SUBJECT: SPECIAL SERVICE CAMPAIGN (SSC) – 10F
(2000 - 2001 MY ECHO AND AVALON TETHER ANCHOR UPGRADE)

Toyota will initiate a Special Service Campaign (SSC) to upgrade the child restraint tether anchors on certain 2000 - 2001 MY Echo and Avalon vehicles.

SPECIAL SERVICE CAMPAIGN 10F

CHILD RESTRAINT UPPER TETHER ANCHORAGE UPGRADE

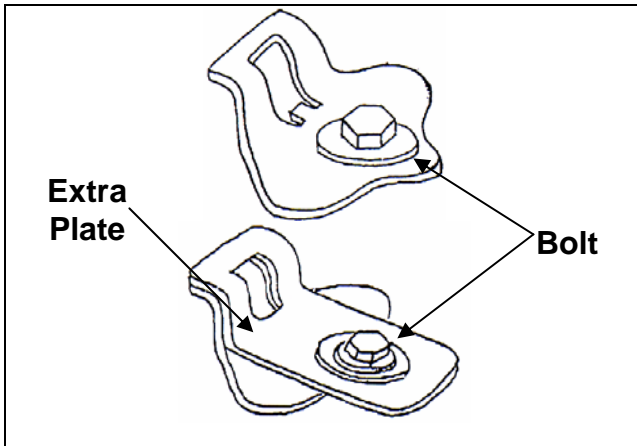
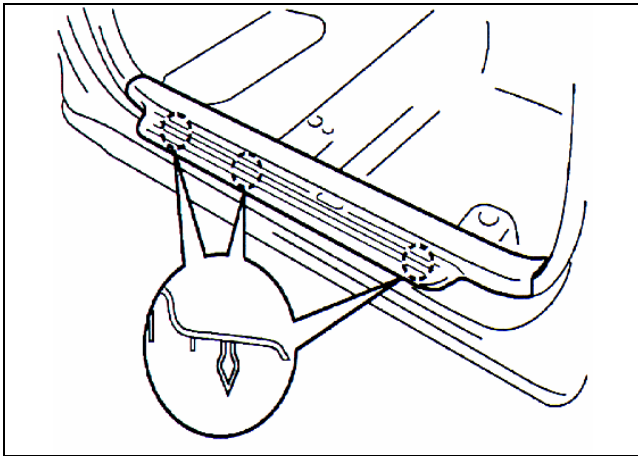
1. **INSPECT THE UPPER TETHER ANCHORAGES FOR EXISTING COUNTERMEASURES**
 - (a) After confirming VIN eligibility through TDN/TIS and checking for an SSC completion label, check the upper tether anchors for the countermeasures shown in the picture.
 - (b) If either of the countermeasures exist, the vehicle does not require this campaign. Return the vehicle to the customer.

13. INSTALL THE UPPER CHILD RESTRAINT TETHER ANCHOR BRACKET UPGRADE KIT

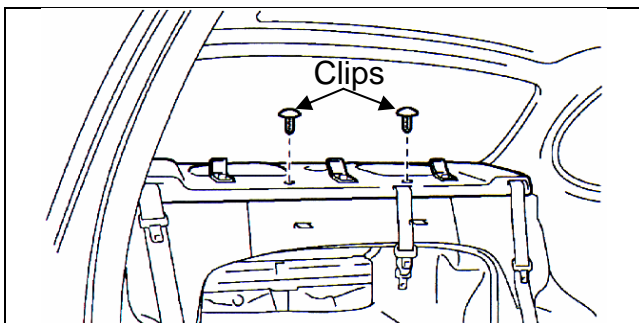
- (a) Install each of 3 anchor bracket upgrades (as shown in picture) with the bolt, nut, and 2 washers onto the existing anchors.

TORQUE: 19.5 N•m (199 kgf•cm, 14 ft•lbf)

NOTE: The tether anchor upgrade kit is to be installed in addition to the factory anchors.

1. INSPECT THE UPPER TETHER ANCHORAGES FOR EXISTING COUNTERMEASURES

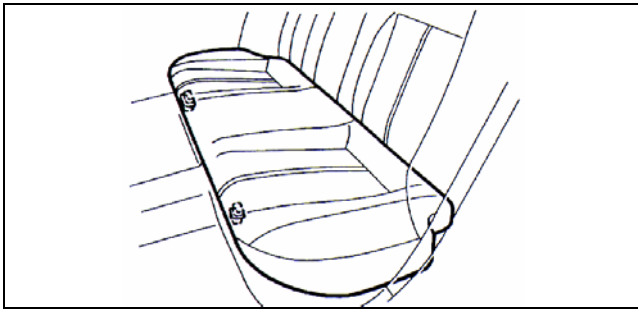
- (a) After confirming VIN eligibility through TDN/TIS and checking for an SSC completion label, check the upper tether anchors for either of the countermeasures shown in the picture.
- (b) If the countermeasures exist, the vehicle does not require this campaign. Return the vehicle to the customer.

6. INSTALL THE UPPER CHILD RESTRAINT TETHER ANCHOR BRACKET UPGRADE KIT (3 ANCHORS)

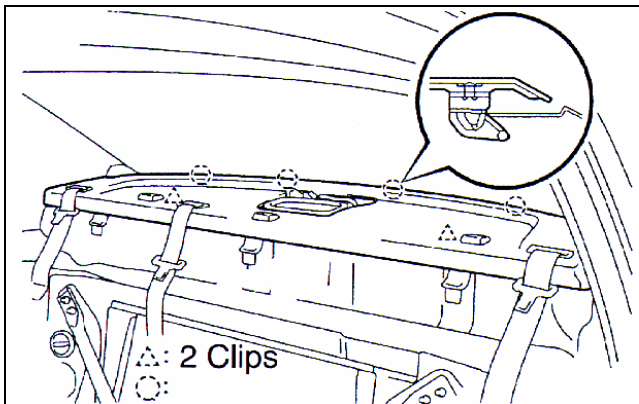
- (a) Install each of 3 anchor bracket upgrades (as shown in picture) with the bolt and nut onto the existing anchors.

TORQUE: 19.5N•m(199kgf•cm, 14ft•lbf)

NOTE: The tether anchor upgrade kit is to be installed in addition to the factory anchors.
